Town of Maynard

January 13, 2026 Planning Board Meeting

2. Public Hearing - 151 Main Street (Continued From December 9, 2025)

Peer Review Comment Form

LAYOUT PLAN

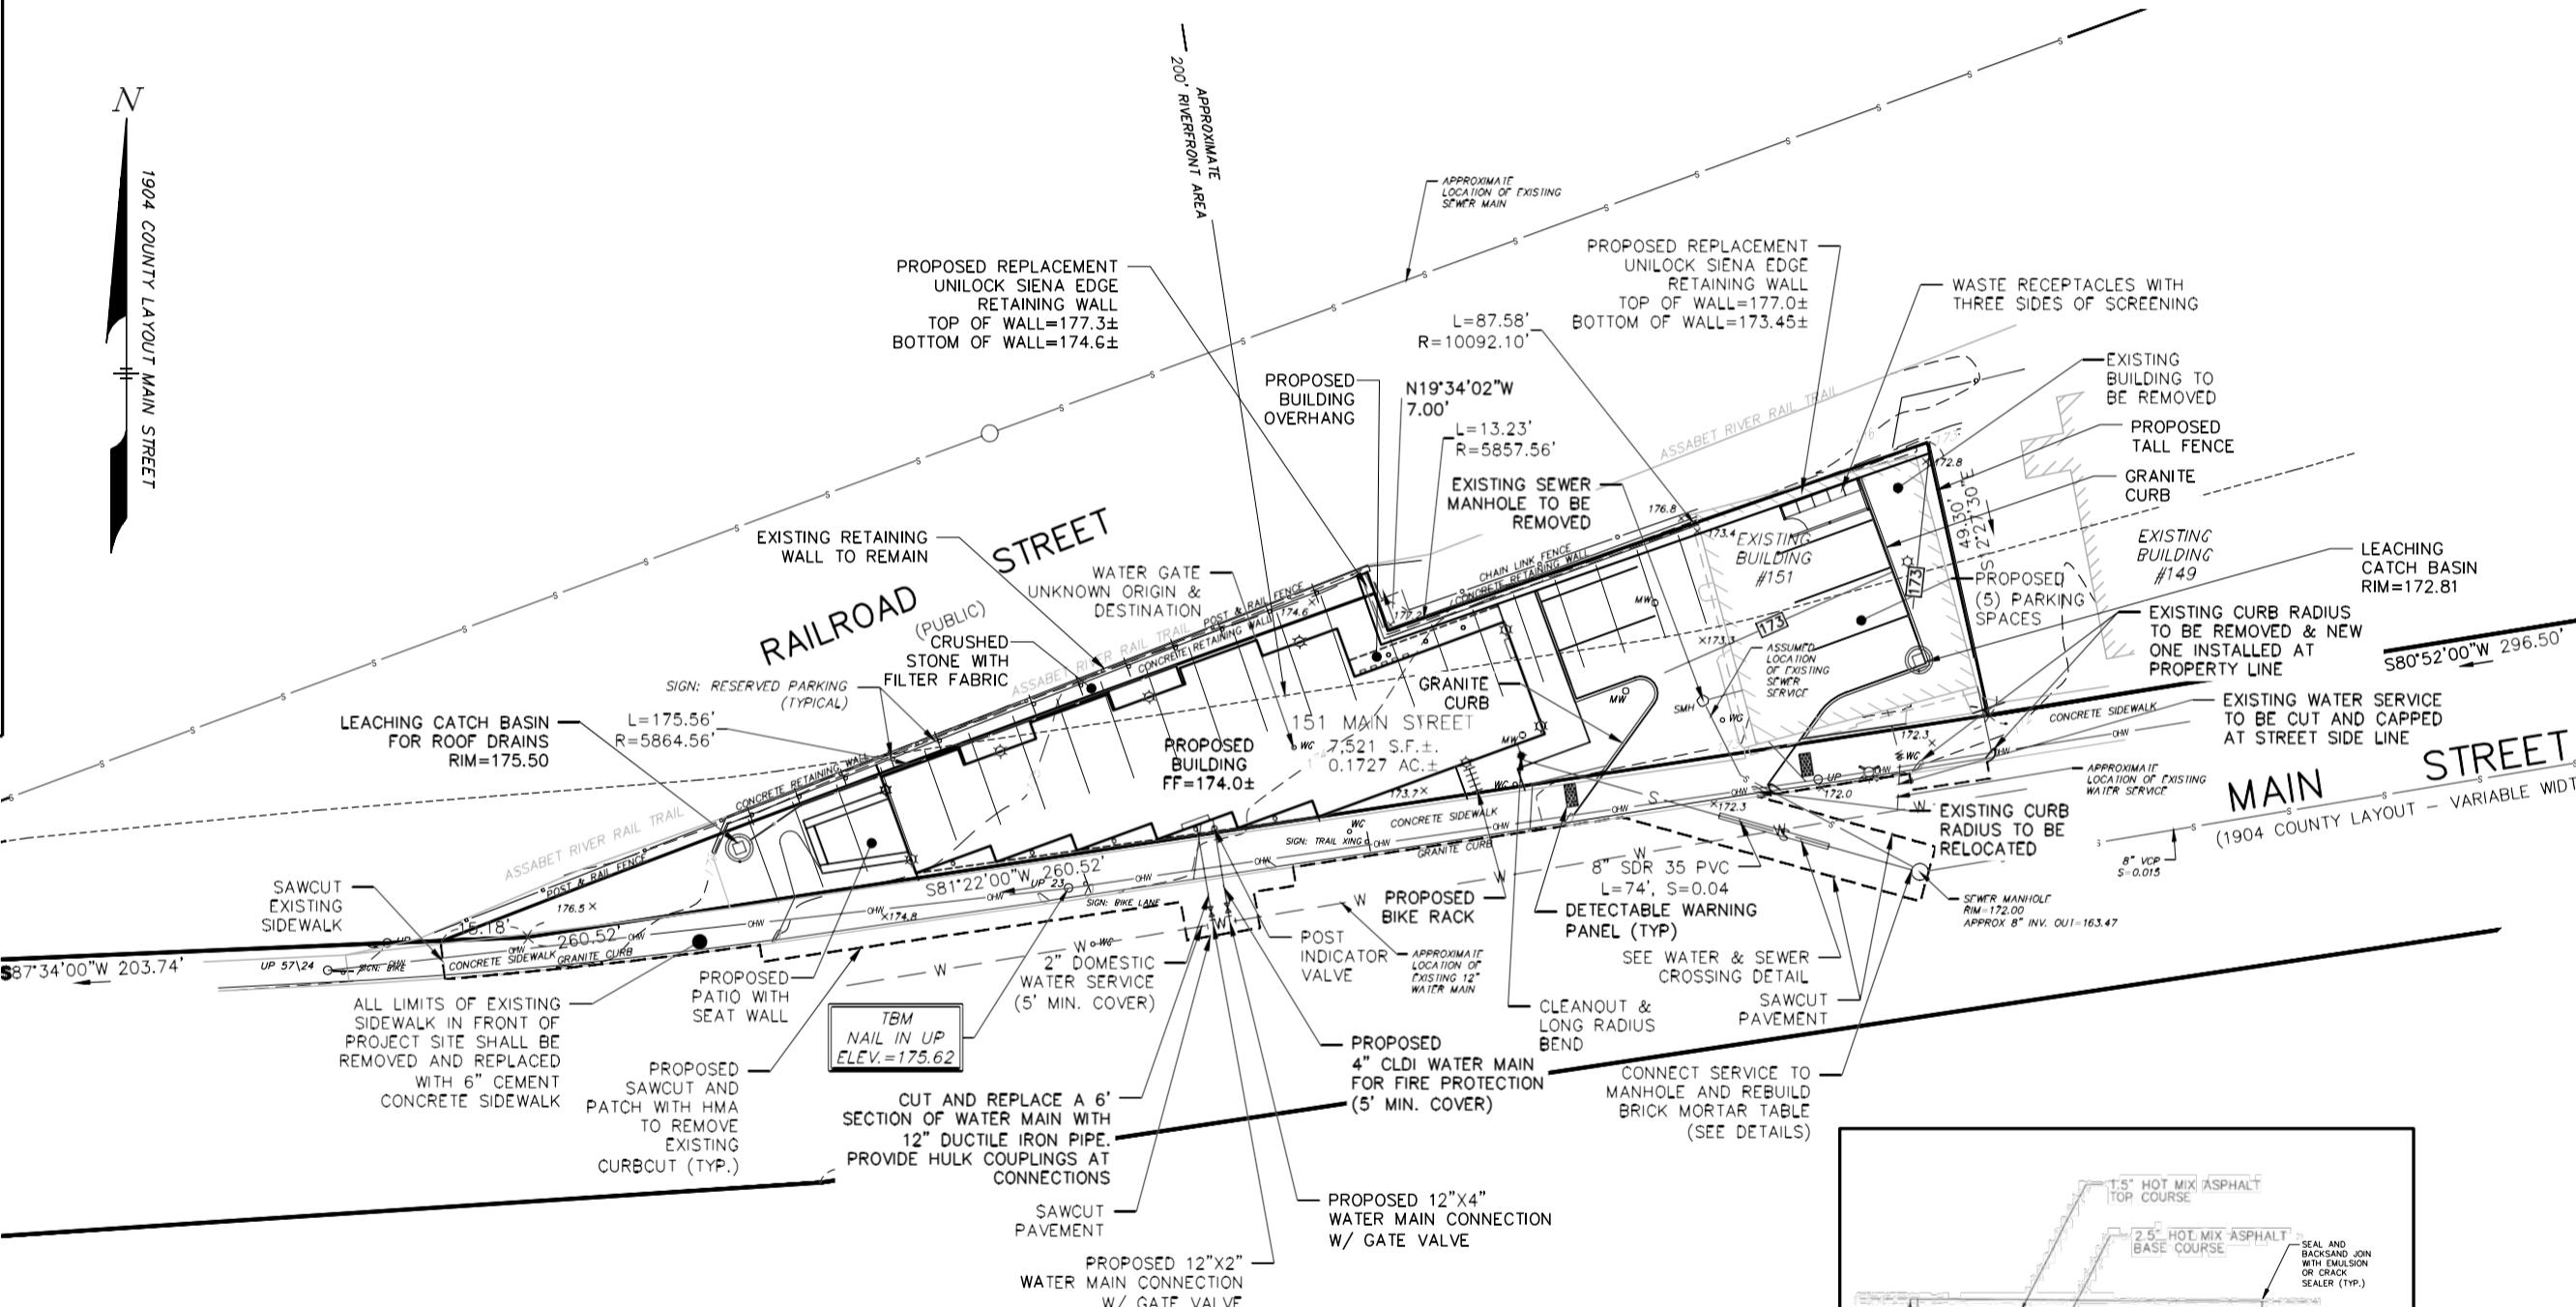
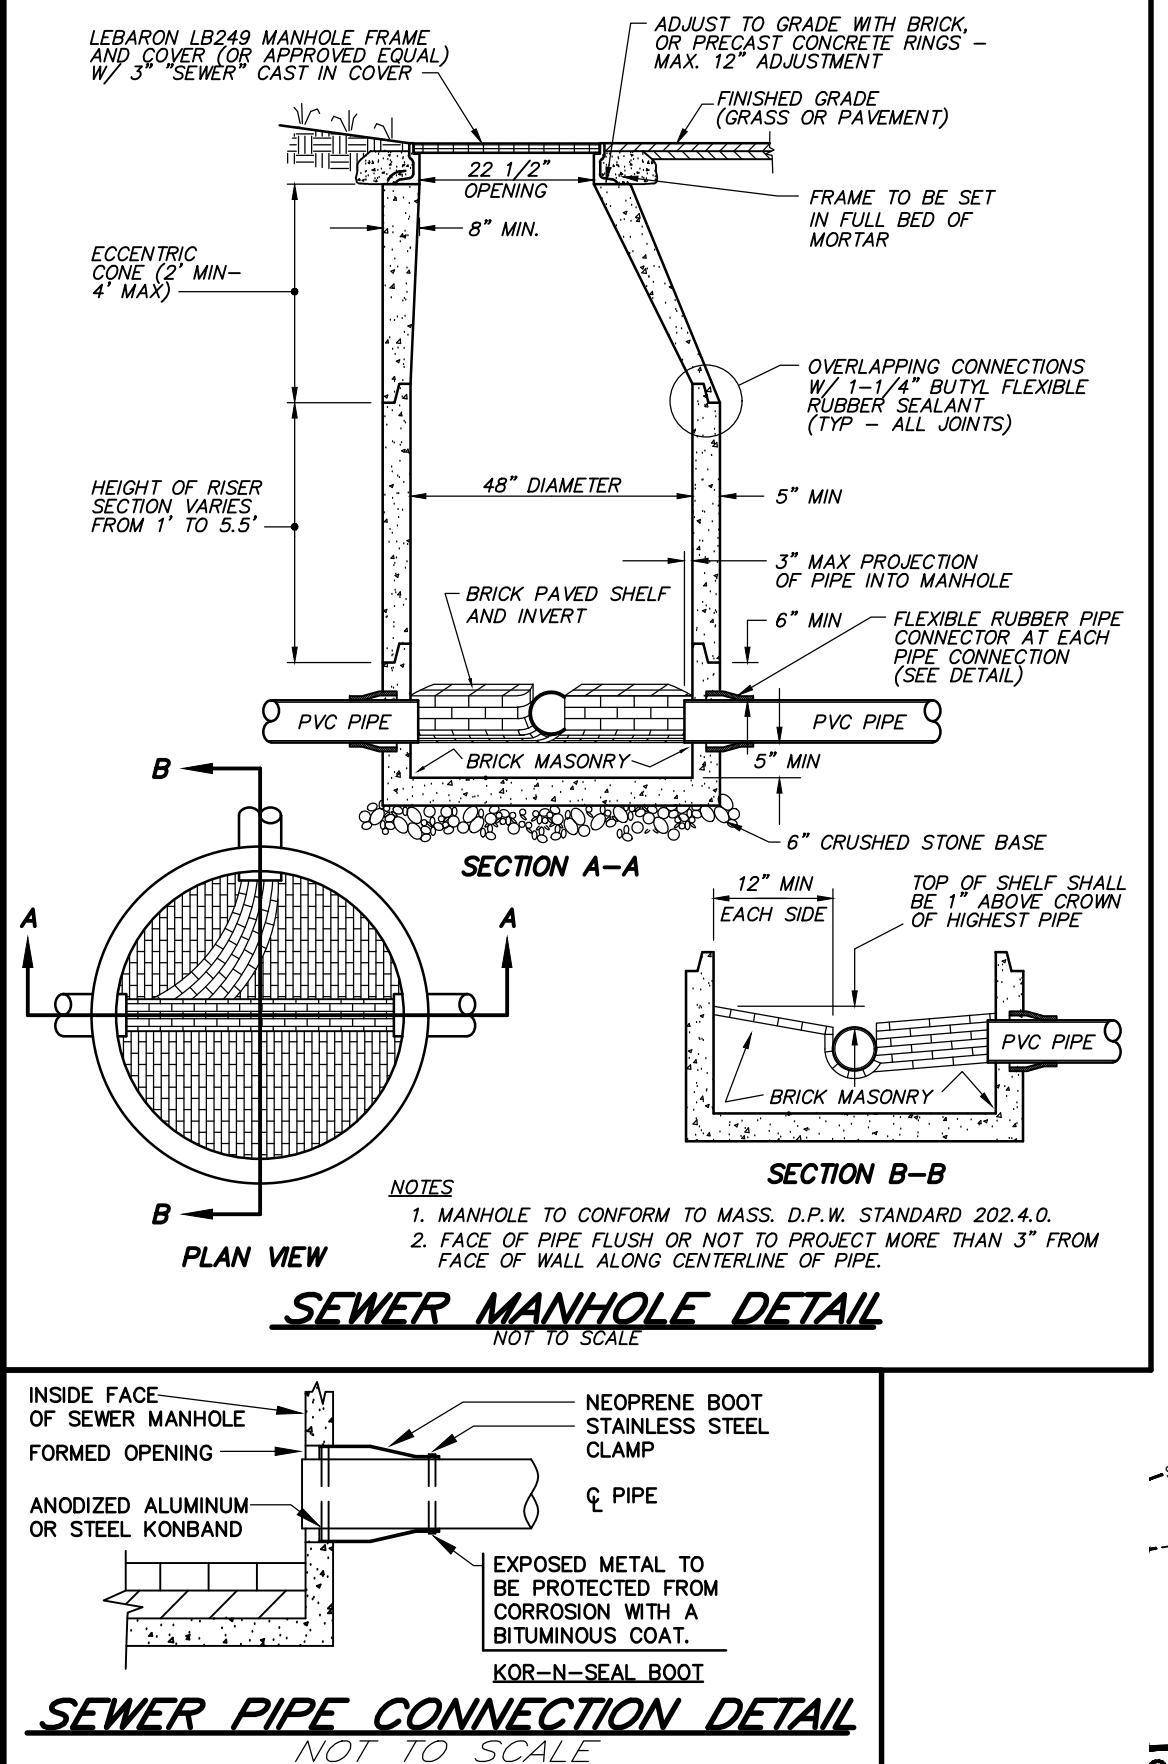
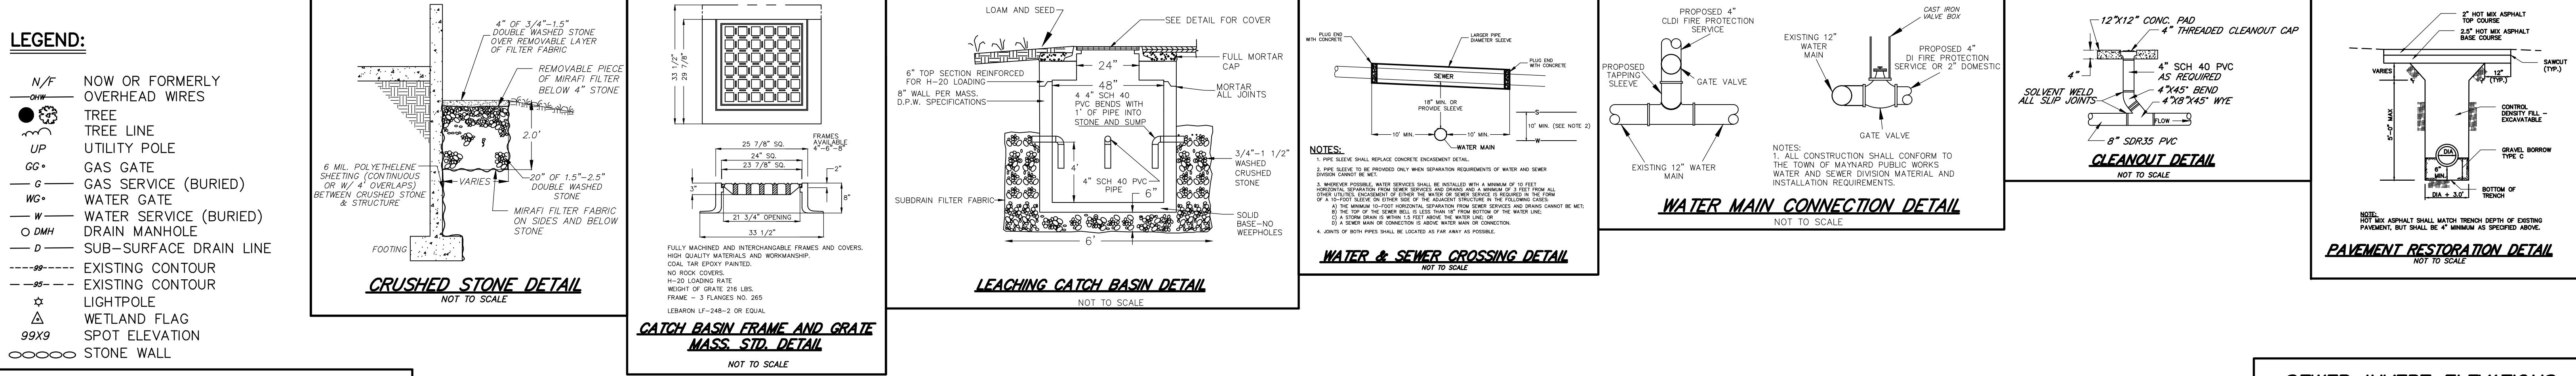
8	Layout Plan		Please clarify if all of the sidewalk south of the site will have vertical granite curb. There are several existing curb radii but only one is noted as being removed. The linework seems to indicate that there will be vertical granite curb. Is the sidewalk and curb along main street being replaced? Proposed grades shall be provided to confirm ADA compliance if the sidewalk will be removed. Saw cut lines shall be added to replace or reset the curb. Please revise.	All sidewalk along the frontage of the property will have vertical granite curb. All existing curb radii except the two for the proposed parking entrance shall be removed or relocated as shown on the plan. Per DPW, the entire sidewalk along the frontage is to be replaced. Sawcut lines added. Proposed spot grades have been added.	JT	12/23/2025
9	Layout Plan		Please confirm why the driveway entrance is angled promoting a left turn entry over a right turn entry. Please provide turning movements to confirm cars can turn right into the parking lot.	Driveway entrance is proposed to maintain existing curb cut and avoid existing fire hydrant and utility pole. Turning simulations are now provided in a detail.	VR	12/9/2025

10	Layout Plan	Zoning bylaws 6.1.10	Per 6.1.10, no parking space or other paved surface other than access driveway shall be located within 20 feet of the front lot line or within 10 feet of any other lot line. The project does not meet these thresholds. Will a waiver be requested for this regulation?	A waiver is requested for the on-site parking.		
10A	Layout Plan	Zoning bylaws 6.1.10	We defer to the Board for approval.			
11	Layout Plan	9.4.6 Special Permit Criteria	The proposed development should provide significant improvements to the parking in the downtown area. There is currently only parking for the residents and not for the people visiting or for employees. The parking on the street is two hour metered parking which does not support employees. Please explain where employees will park. Will this be met by a separate lot per 9.4.8.1?	A waiver is requested for the on-site parking. Employees will park in public lots.

11A	Layout Plan	9.4.6 Special Permit Criteria	We defer to the Board for approval.			
12	Layout Plan	PB Rules & Regs H.10	Snow storage is not identified on the plans. Please confirm how snow will be handled?	Snow will be stored in the newly introduced green spaces around the parking area. Any excess snow will be removed from the site.	JT	12/23/2025
13	Layout Plan	ADA	Per ADA parking requirements for parking lots with 1 to 25 parking spaces a minimum number of 1 accessible parking space is required. In the Planning Board Hearing, it was mentioned that ADA parking was not required by the applicant. Please provide back up documentation describing the exemption. Will any units provide ADA mobility features?	Per Section 6.1.12 of Maynard's Zoning Bylaw, a handicapped parking space is only required once the total number of spaces reaches 6. Per 521 CMR 23.2.1 of the Architectural Access Board, an accessible space is only required when the total parking in the lot reaches 15 spaces. The proposed parking area only has 5 spaces.	VR	12/9/2025

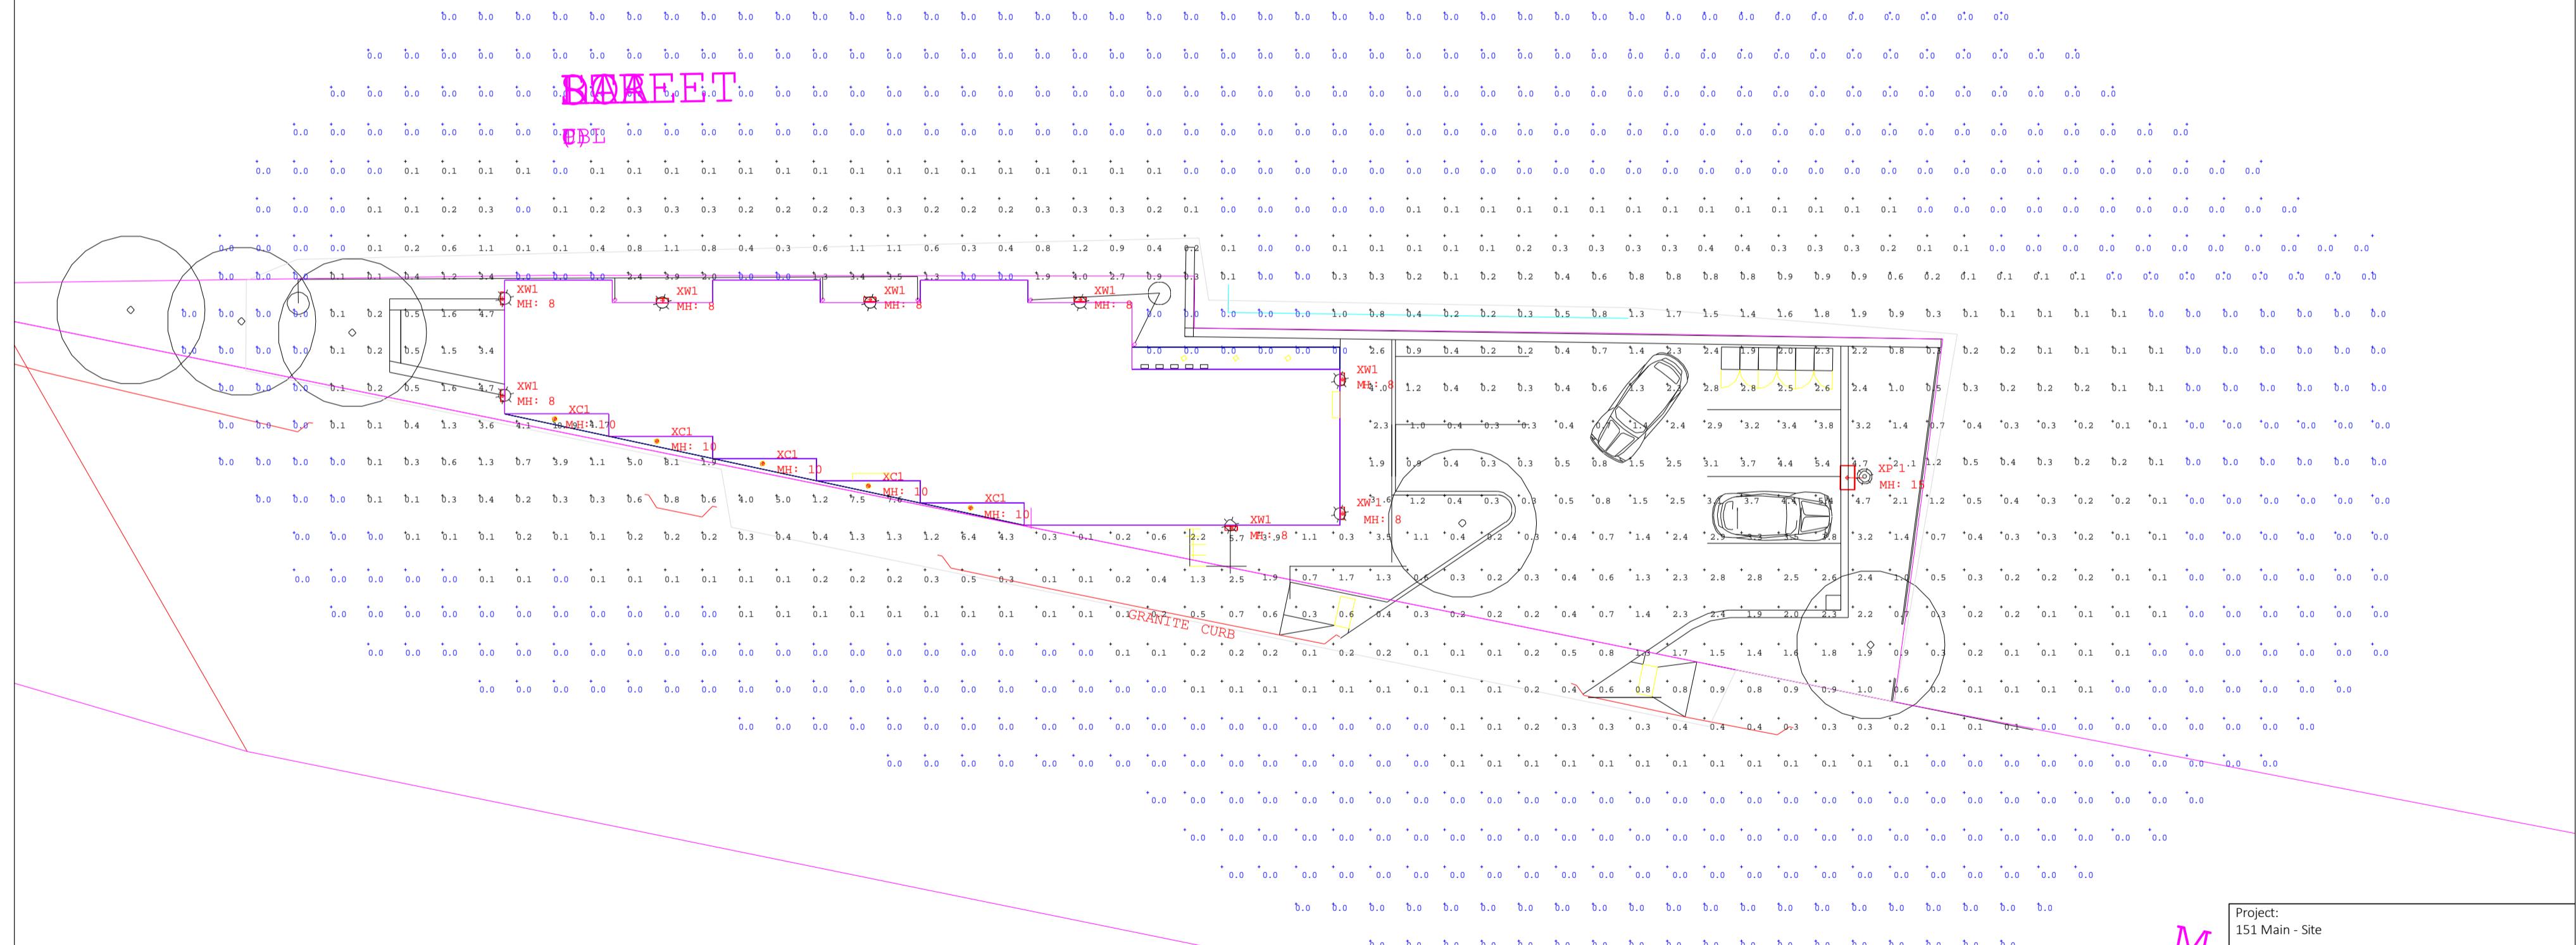
NO.	SHEET NO.	SECTION	GREEN'S COMMENT	Applicant's RESPONSE	CONFIRMED BY	DATE
30	Photometric Plan	PB Landscape Regs 5.9.2	Please confirm the shut off controls such as sensors, timers, and motion detectors to turn off lights when not needed.	Exterior lighting will be on timers located in mechanical area on the ground floor	JT	12/23/2025
31	Photometric Plan	PB Landscape Regs 5.9.2	Light spill across the property lines should not exceed 0.1 foot candles adjacent to business properties. The current light spill on the adjacent property to the east exceeds 0.1 foot candles. Please revise.	Please see PB comments regarding light levels at entries and north side.		
31A	Photometric Plan	PB Landscape Regs 5.9.2	We defer to the Board for approval.			
32	Photometric Plan	PB Landscape Regs 5.9.2	It is recommended that at building entrances and sidewalks foot candles do not exceed 5 fc. Please revise.	Please see PB comments regarding light levels at entries and north side.

32A	Photometric Plan	PB Landscape Regs 5.9.2	We defer to the Board for approval.			
33		Stormwater Management Regulations 7.A	The required stormwater treatment volume was not provided. Therefore, it is assumed that the project disturbs less than 10,000 sf. Please confirm the square feet of disturbed area is less than 10,000 sf or provide the required and provided stormwater treatment.	The project disturbs less than 10,000 square feet (the entire lot is only 7,521 square feet).	VR	12/10/2025
